CITY OF PORTLAND, MAINE

HISTORIC PRESERVATION BOARD

HISTORIC PRESERVATION BOARD MEETING

**WORKSHOP
21 ORCHARD STREET**

01 North Elevation
Scale: 1/4" = 1'-0"

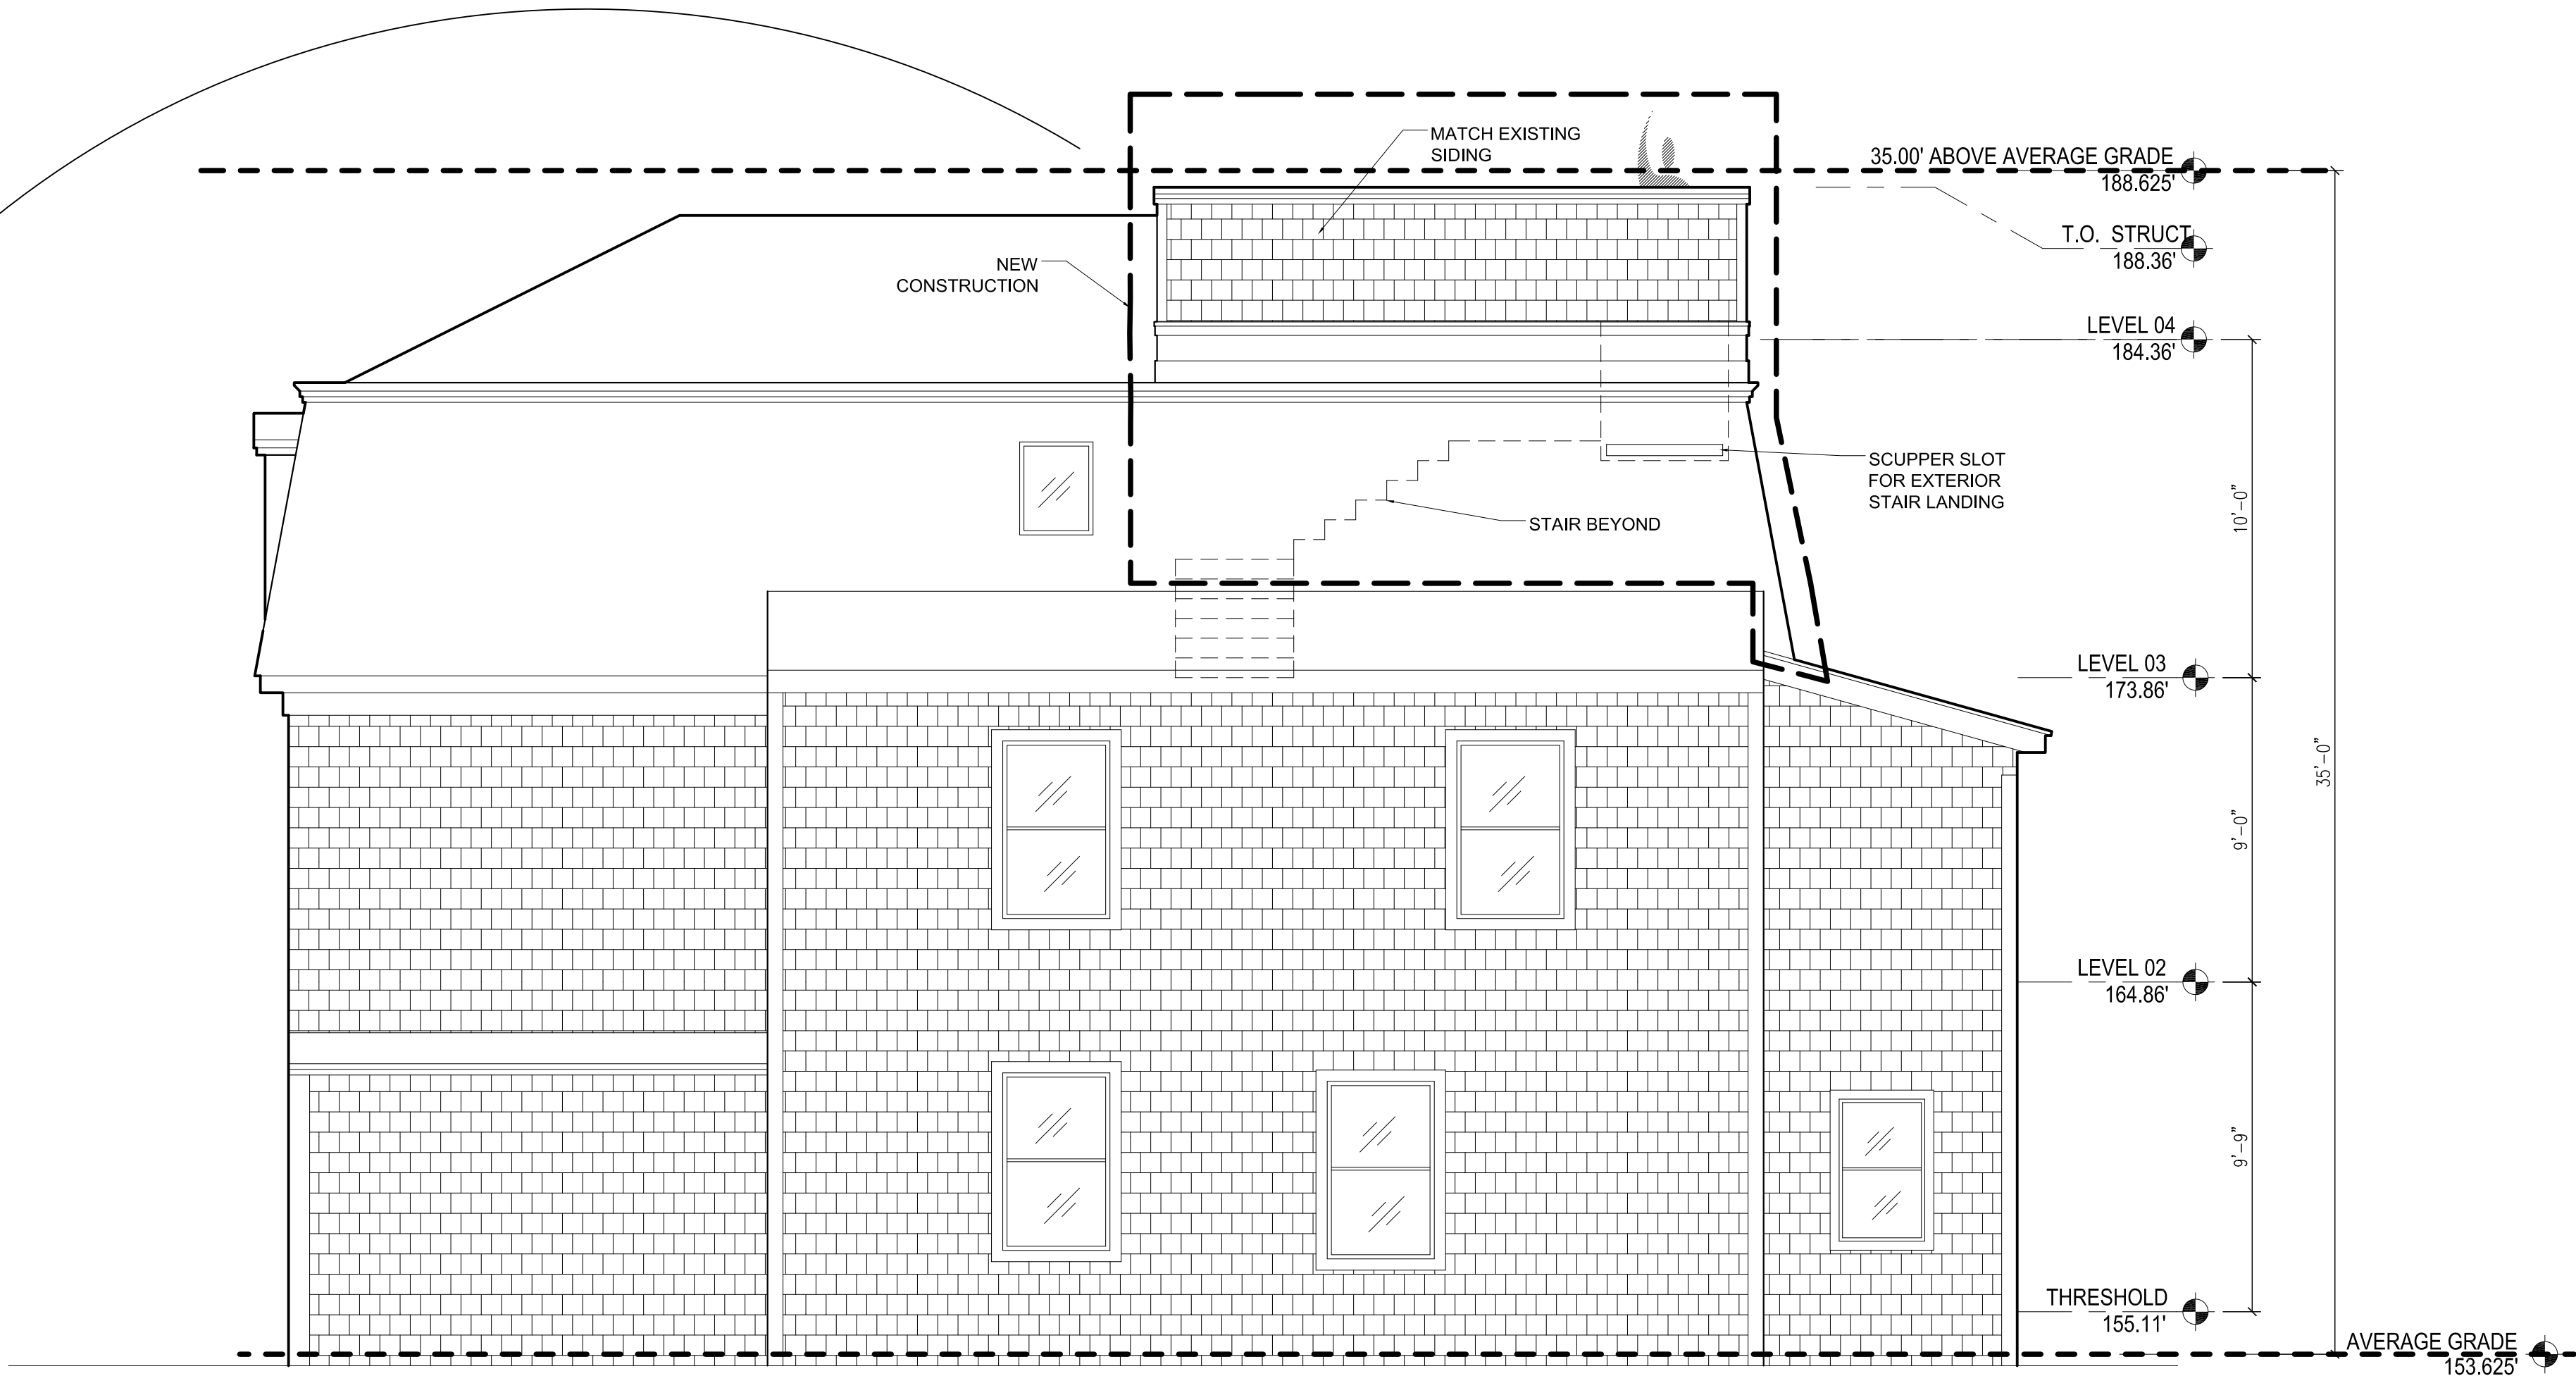
The applicant's desire to expand the building at the rear to accommodate another unit on the third floor has prompted the question of how best to treat the roof form. The proposal to extend the mansard roof form over the rear bays of the house calls into question the applicability of Standard # 3, which discourages "alterations that have no historical basis or [which] create a false sense of historical development". In this case, we have no documentation to confirm this area of the building once featured a mansard roof, although other visual cues suggest this might have been the case. Extending the sloped portion of the mansard would, however, remove the clearly incompatible shed roof and create greater visual consistency. In staff's view, this would be an acceptable direction to take. Perhaps subtle distinctions in treatment, such as eliminating the brackets and dentils at the cornice line, would help distinguish the "original" roof from the extension.

Regarding the applicant's proposal to add a roof deck and stair tower on top of the extended mansard, it could be argued that these added elements undermine the consistency achieved by extending the mansard and reintroduce a level of visual complexity at the building's rear roofline. On the other hand, these interventions are set well back from the street. Although visible, the location makes them less prominent. In evaluating these changes, Board members should consider the degree to which they will impact the building's overall historic character. Like many houses on Munjoy Hill, 42 Lafayette Street has been altered over time to accommodate changing needs. The question for the Board is whether the proposed alterations, in sum, are generally compatible with the historic structure.
